**REVISED PERMIT MODIFICATION REQUEST
SECTION 311 PUB. L. 108-137/SECTION 310 PUB. L. 108-447
AND
REMOTE HANDLED WASTE**

The Carlsbad Field Office of the U.S. Department of Energy (**DOE**) and Washington TRU Solutions LLC (**Permittees**) are submitting this revised Permit Modification Request (**PMR**) to the Hazardous Waste Facility Permit (**HWFP**) for the Waste Isolation Pilot Plant (**WIPP**) in accordance with Permit Condition I.B.1 and 20.4.1.900 New Mexico Administrative Code (**NMAC**) which incorporates Title 40 Code of Federal Regulations (**CFR**) Section 270.42.

Figure 5 VERIFICATION and EXAMINATION PROCESS AT WIPP

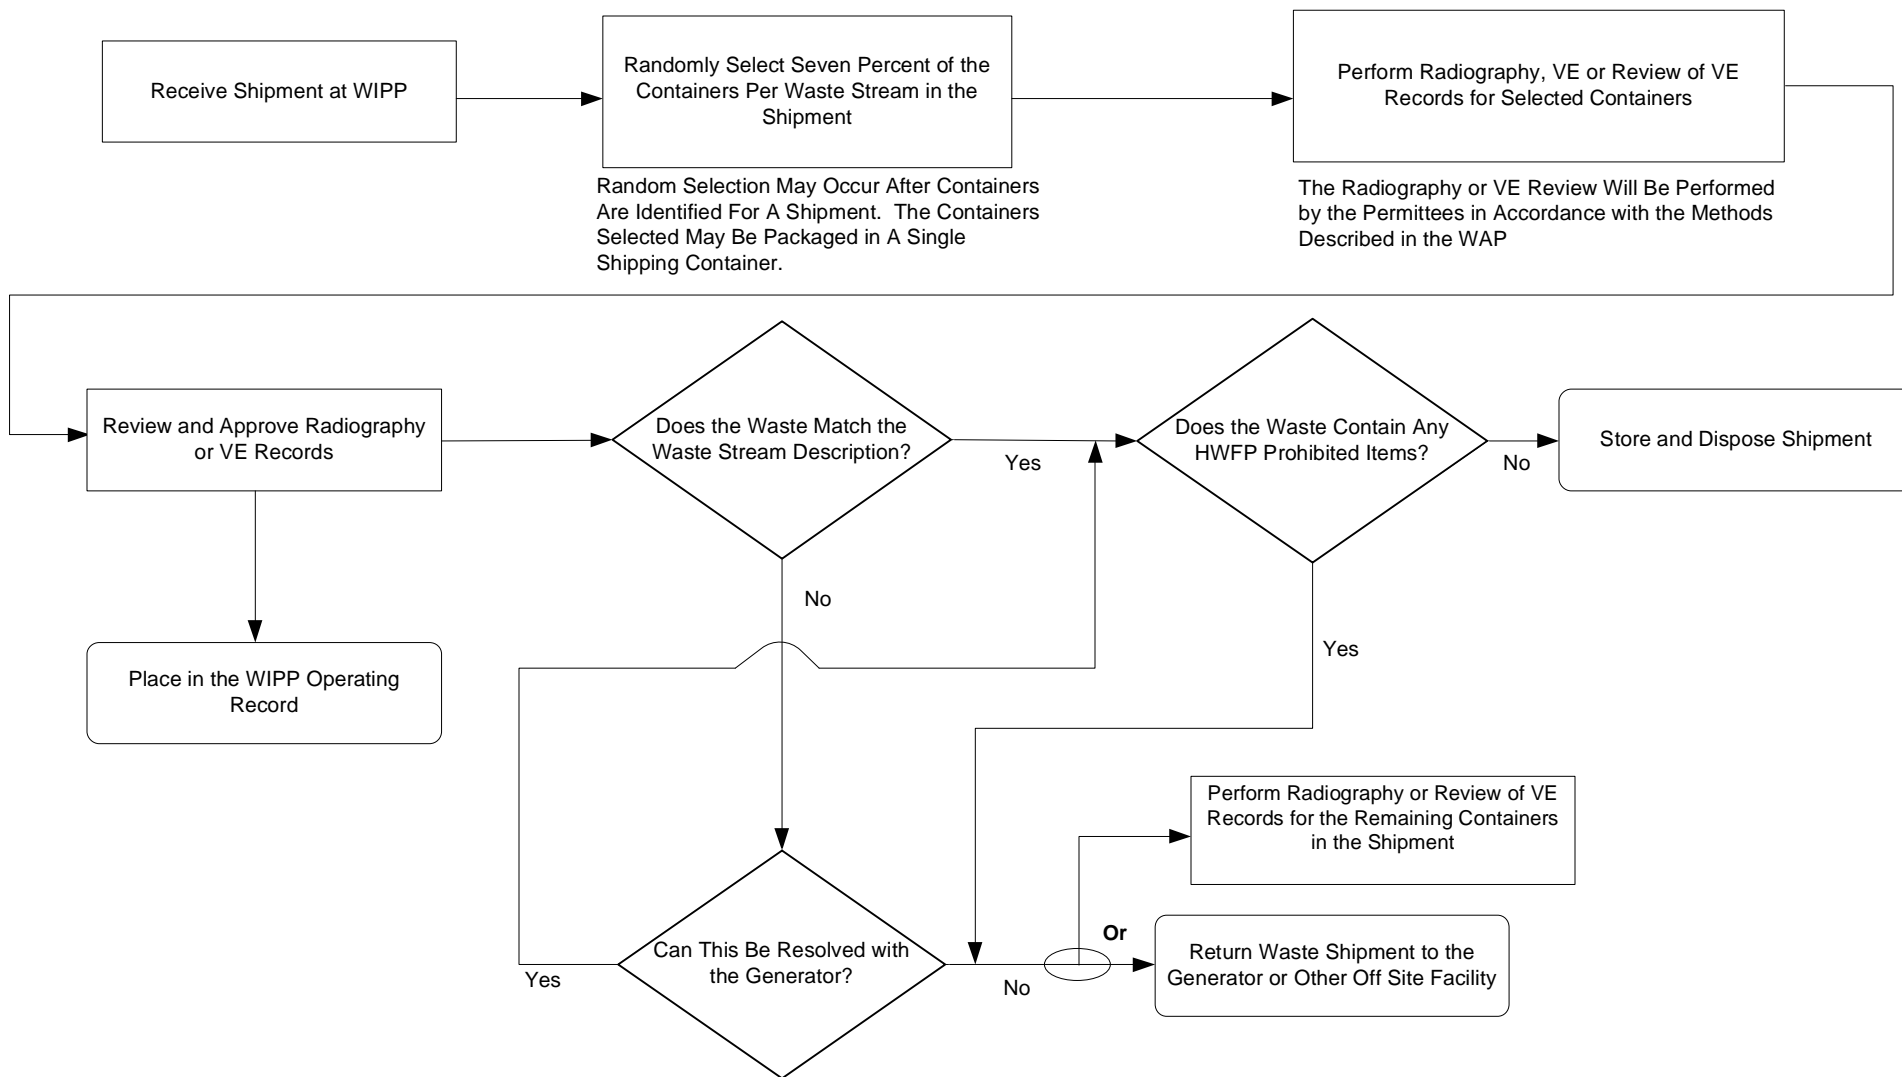
The revised PMR proposes the following Permittee level waste analysis processes: 1) waste stream screening and verification, including verification that the assigned HWNs are allowed for storage and disposal by the HWFP; 2) the use of radiography, visual examination (VE), or the review of VE records to verify that the waste contains no ignitable, corrosive or reactive waste; and 3) an audit and surveillance program. The Permittees will conduct radiography, VE, or the review of VE records of a statistically representative subpopulation of the waste either at the WIPP facility or at the generator/storage site. See Figure 3, Waste Verification and Examination Process; Figure 4, Verification and Examination Process at the Generator/Storage Sites (or Other Off-Site Facilities); Figure 5, Verification and Examination Processes at WIPP.

Permittee level waste analysis may occur either at the generator/storage site or at the WIPP facility. Waste arriving at WIPP would be segregated into staging areas, pending examination. Staging areas will be separate from permitted storage areas. As discussed in Section 1.2.2.2 above, shipments typically arrive at the WIPP site as assemblies from which specific containers will be removed for waste examination. Until waste examination of the specified container is complete, the entire assembly will be "tagged" to indicate that waste examination has not occurred (HWFP Section M1-1c(1) of Attachment M1).

Figure 6 Proposed Process for Room-Based VOC Monitoring

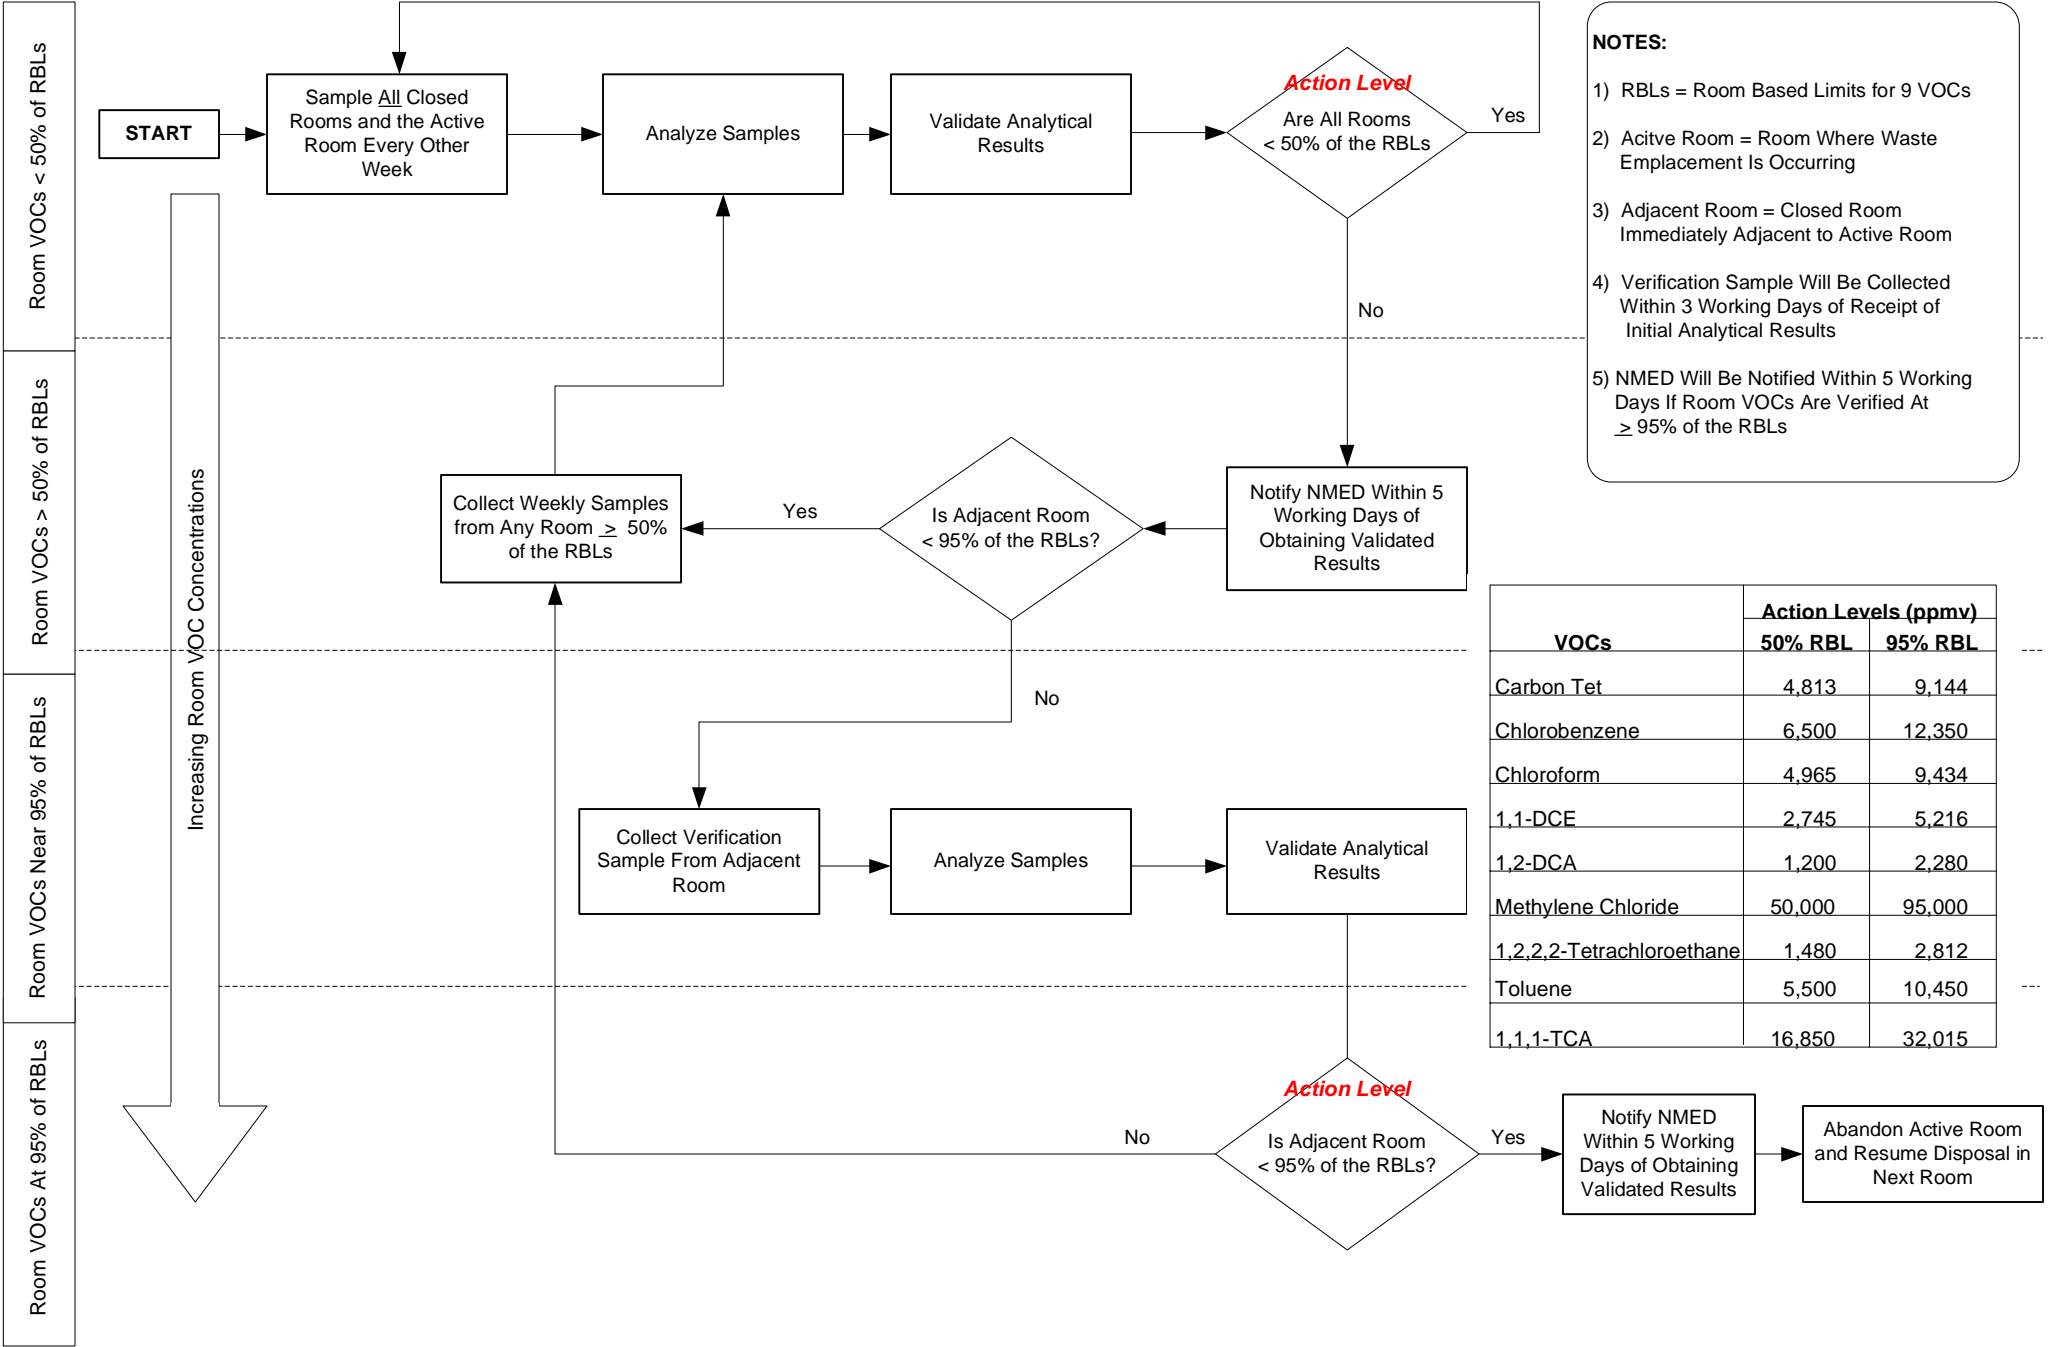
No changes to the environmental performance standards are proposed. The current monitoring of VOCs at Stations VOC-A and VOC-B in the underground will remain unchanged. Consistent with the provisions of Sections 311(b)/Section 310(b), this revised PMR proposes direct measurement of the VOC concentrations inside disposal rooms in which waste has been emplaced. Monitoring continues until the active panel is closed.

- A sample head will be installed inside each active RH TRU and CH TRU mixed waste disposal room behind the exhaust drift bulkhead.
- When a disposal room is filled, another sample head will be installed in the inlet of the room, ventilation barriers installed, and collection of closed room samples will commence.
- This sequence will proceed in the remaining disposal rooms until panel closure activities are initiated by installing the inlet air ventilation barrier in Room 1 of the panel.

This revised PMR proposes a bi-weekly sampling frequency for disposal rooms based on the experience from actual measurements of VOCs in closed disposal rooms in Panel 1. Bi-weekly frequency is conservative and appropriate for the room-based monitoring program. Station VOC-A and VOC-B samples will continue to be collected twice each week.

Action levels for the room-based VOC monitoring program proposed in this revised PMR are modeled after those in the current confirmatory VOC monitoring program. If the results of the bi-weekly monitoring shows that the concentration of one half the Room-Based Limit (**RBL**) for any target analyte in any room is reached, the sampling frequency will be increased to once per week for that room, and NMED will be notified. The once per week sampling frequency will continue until concentrations in the room(s) fall below 50 percent of the RBL, or until closure of the panel, whichever occurs first.
